# ICHD - ENVIRONMENTAL HEALTH DIVISION

## SEPTIC: IMPROVEMENT PERMIT / AUTHORIZATION TO CONSTRUCT / OPERATION PERMIT / EXISTING SYSTEM

SITE ADDRESS: 118 Binns Rd Mooresville NC 28117 | PHONE: 704-662-6400 | ALT. PHONE

NARD K BEALER FAM REVOC TR FAMILY SUBDIVISION SEPTIC SITE PLAN; REMNANT TRACT; PARCEL NO. 4624064331 DEC. 3, 2021; rev 1.3.21
site plan from Williams Land Surveying. Septic lines approximatley sketched on site plan by Penninger Soil Consulting. Septic system and well must be
oved and permitted by ICHD

AS BUILT SKETCH

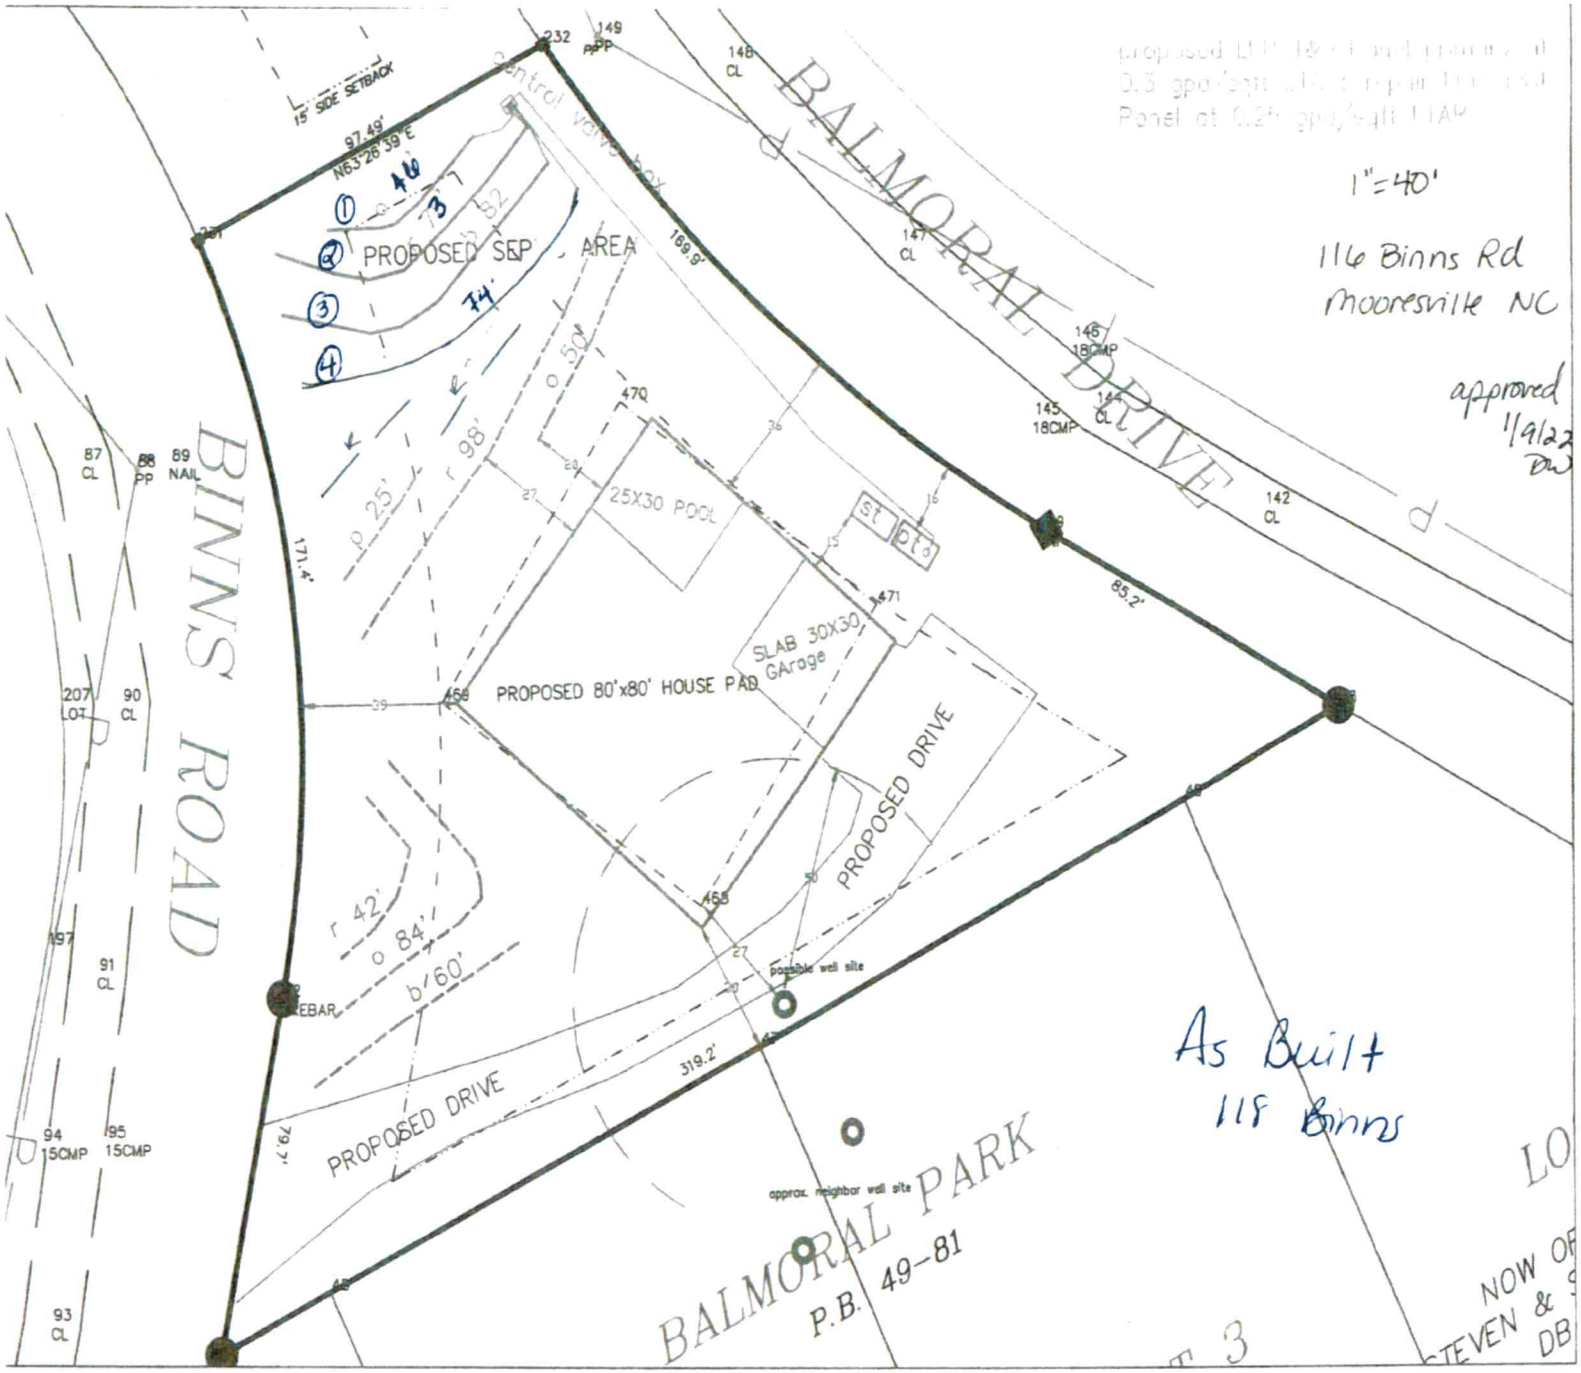
DW 1/24/23
- verify tanks are ≤ 36" when covered
- Check outlet ~~for~~ drainage pipes - looked to be coming out by tanks/supply

- verify fill removed from lines before signing off → see attached email
- verified 2/7/23

7/25/2023 - Pressure Head / Alarm Check / Control Panel resins ✓ Electrical Good

- Needs Floats Set ✓
- Needs Rope on Pump ✓
- Needs Electrical Sealed to Control Panel ✓
- Needs Maintenance Contract ✓

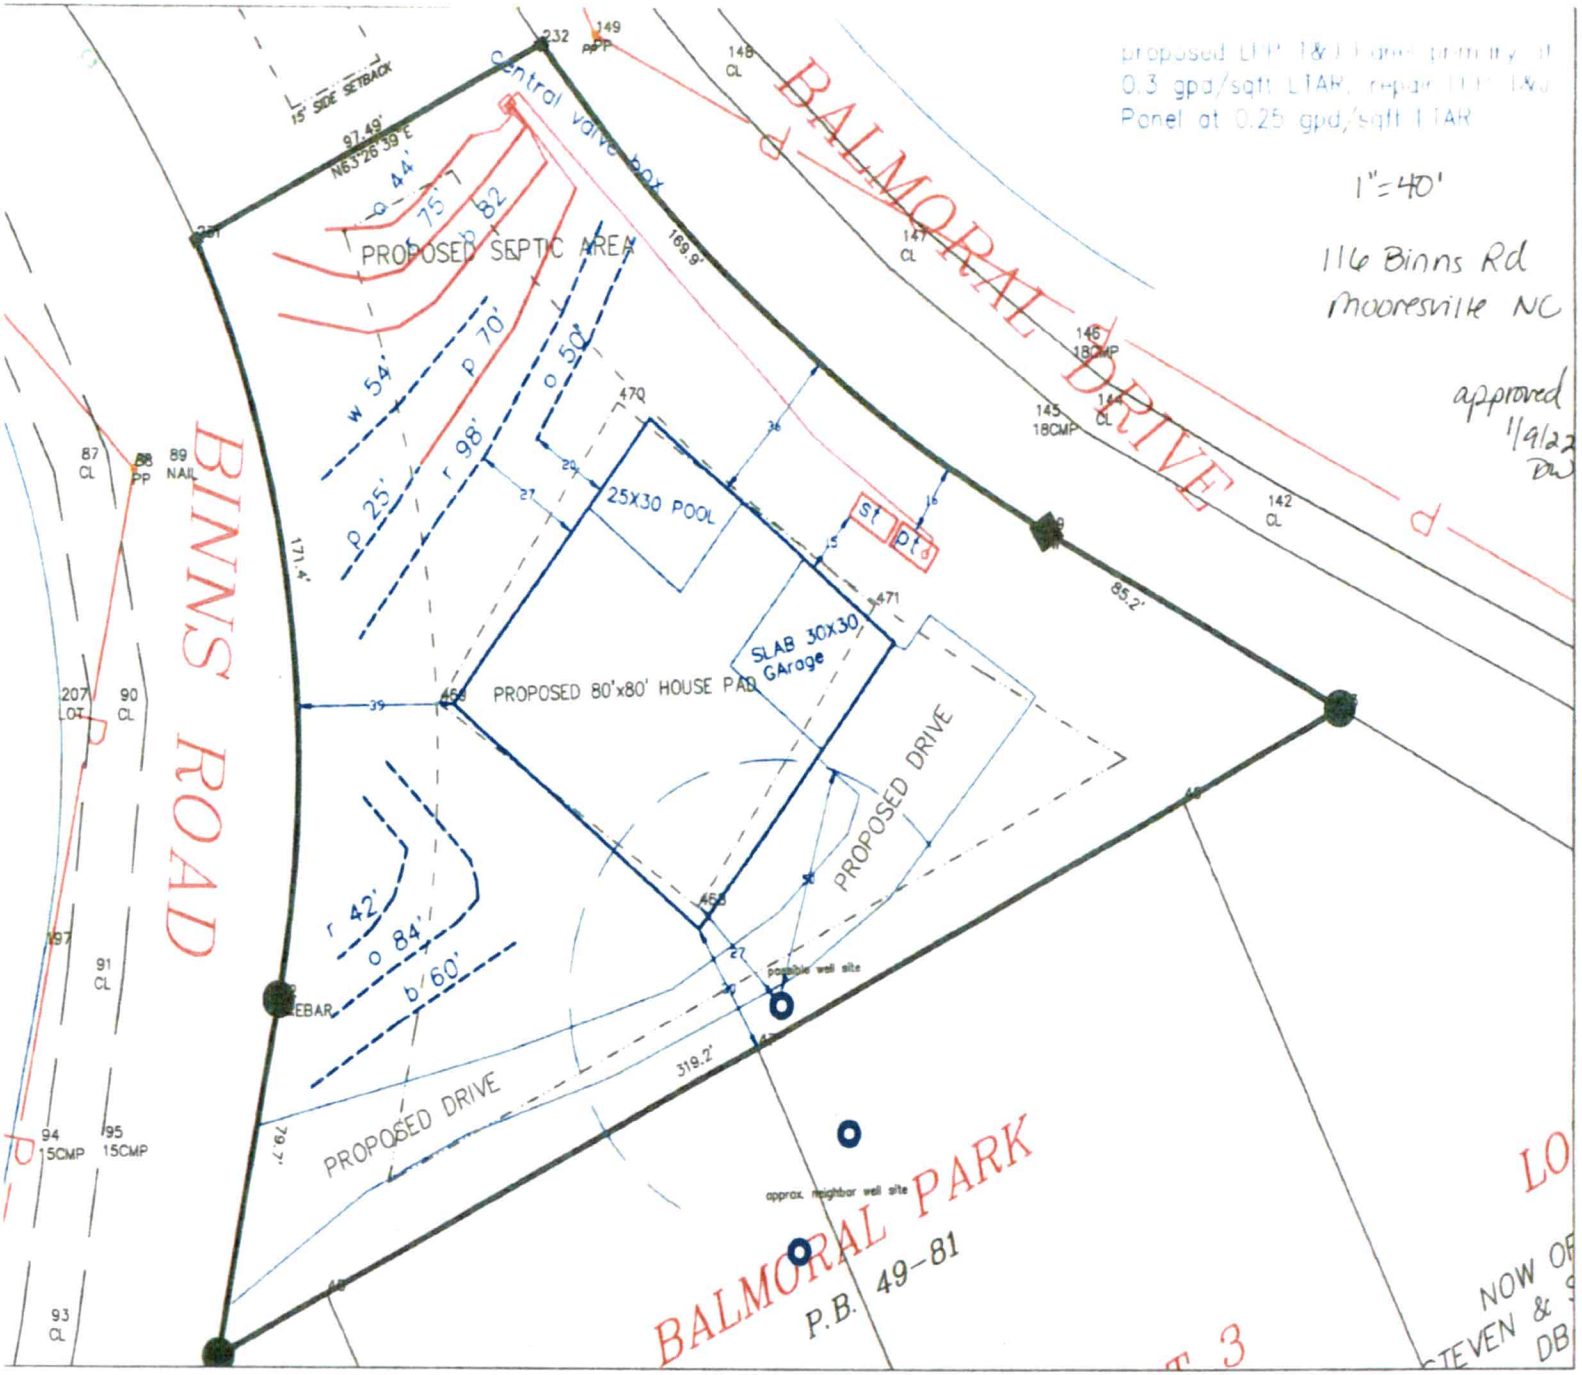
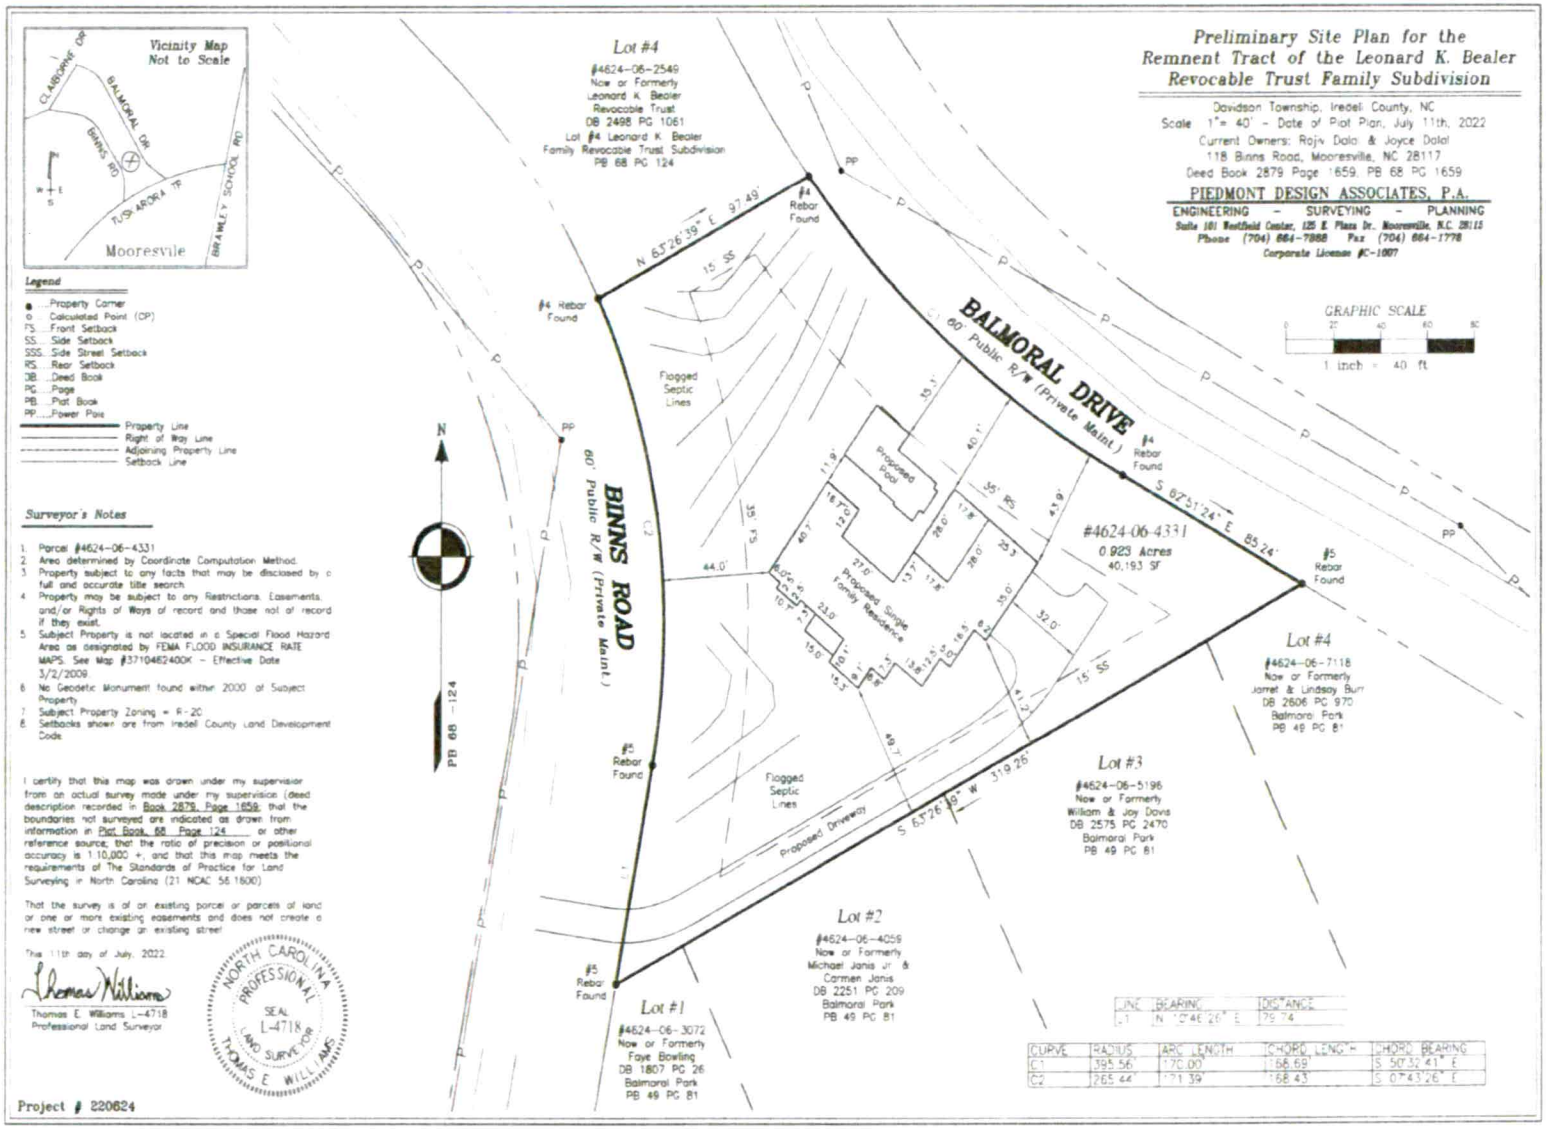
Good morning -
Can you please pass this along to the site manager for 118 Binns? There is fill dirt on the drainfield, about 20' from the ends closest to Binns Rd. I have the drainlines numbered on the attached sketch - please have someone remove fill dirt from each line so the standpipe has the indicated amount exposed. Michael Powell (828-781-5737), the installer, can give you more information if needed. We cannot pass the drainline installation without seeing this dirt removed.

Line 1 = Should have 3" pipe showing
Line 2 = Should have 6" pipe showing
Line 3 = Should have 12" pipe showing.

Again, this fill extends from the ends with the standpipes in approximately 20 feet. They do not need to remove any further than that & any removal must be done carefully so the product is not damaged.
